Implications of Village Centers Zoning Revisited

Richard Rasala

October 25 2022

This document represents my first impressions of the Village Center Presentation of October 24 2022.

The Newton Corner Zoning Map below is taken from page 31 of this slide presentation.

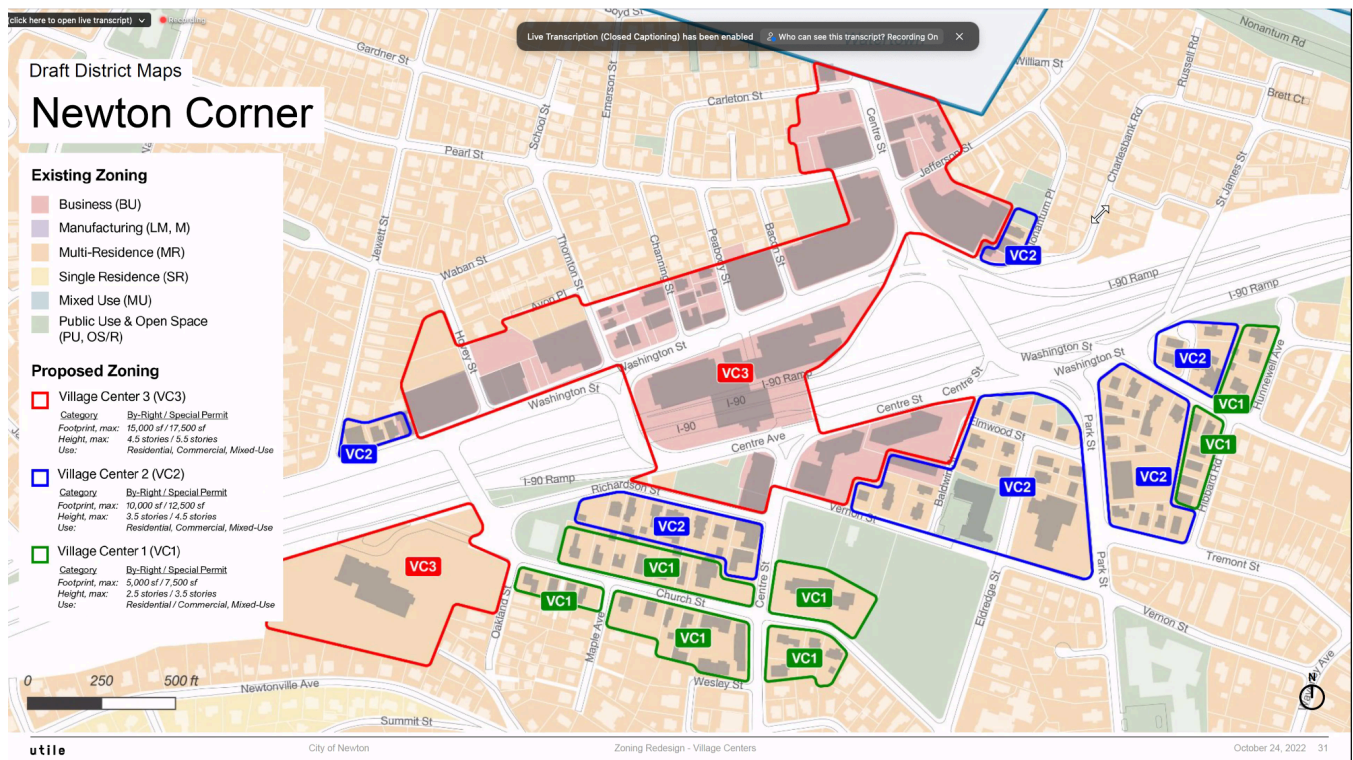
In my opinion, the attachment of the VC2 and VC1 areas in the south and east portions of the Newton Corner Zoning Map is *entirely gratuitous*.

The VC2 and VC1 areas shown in the south contain **primarily private homes** with the following *exceptions*:

The VC2 and VC1 areas shown towards the east also contain **primarily private homes** with the following *exceptions*:

The number of private homes included in the VC2 and VC1 areas is 71. This is enormous.

I think that the number of private homes that are being rezoned for tall buildings (4 or 5 stories by special permit) and for semi-commercial use (aka mixed-use) **is quite excessive.** I think that those who were tasked with doing the zoning for Newton Corner felt pressure to insert VC2 and VC1 areas whether or not doing that made sense with the Newton Corner context on the ground.

All VC2 and VC1 areas be dropped from the Newton Corner Zoning Map.

Keep in Newton Corner only the central VC3 area (the hotel, office building, and other large buildings near the pike).

Aside: The point of zoning the land of the YMCA as VC3 escapes me since the Y will be around for a long time.

*** Assign VC3 only to the central area on the Newton Corner map that encloses the hotel, office building, and other massive buildings and assign VC3 to NO other village center location in the city.**
